The present communication responds to the Final Action mailed July 6, 2009.

The present communication amends the Drawings with Replacement Sheets. The significance and scope of the amendments is explained in the section entitled In The Drawings.

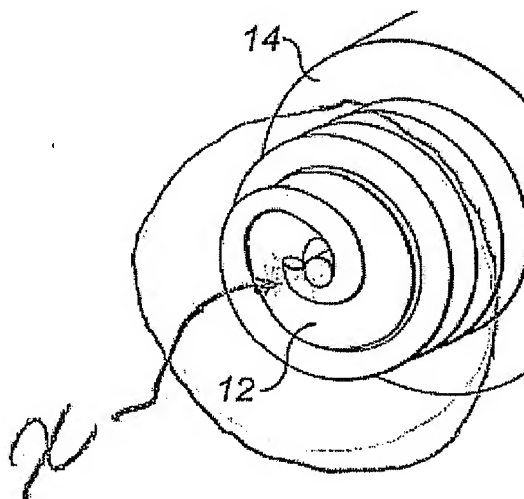
Prior art Figs. 1 and 2 do not disclose the limitation in claim 1 and 32 which reads a single homogeneous insulated wire forms both the coil and the central conductor. The term homogeneous recited in the claims means having a uniform structure. The term single means one. Thus, Applicant's recited claim limitation means that the coil and the conductor form one uniform structure. The prior art does not show a central conductor and coil which forms one uniform structure. The prior art as illustrated below shows two wires. Each wire can be seen below at the "X".

The prior art does not anticipate applicants claim limitation which requires one uniform structure. Accordingly, the rejection to claims 1 and 32 should be withdrawn.

Fig 2.

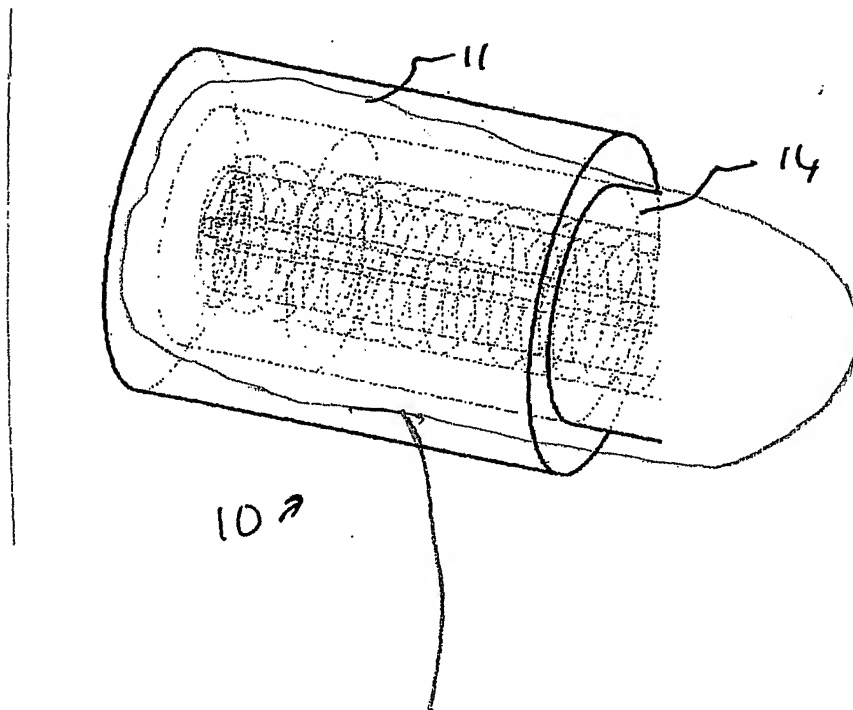
Applicant submits herewith Replacement sheet 1/2. The sheet replaces original sheet 1/4 and 2/4. Figs. 1 and 2 on Replacement Sheet 1/2 were labeled prior art. Reference numbers 18, 10 and 16 have been removed from Fig. 1. Reference number 10 has been removed from Fig. 2. Additionally, the coiling and internal structure shown in original Fig. 2 has been clarified. A marked sheet showing where the coiling and internal structure has been clarified, is attached to the action.

item clarified
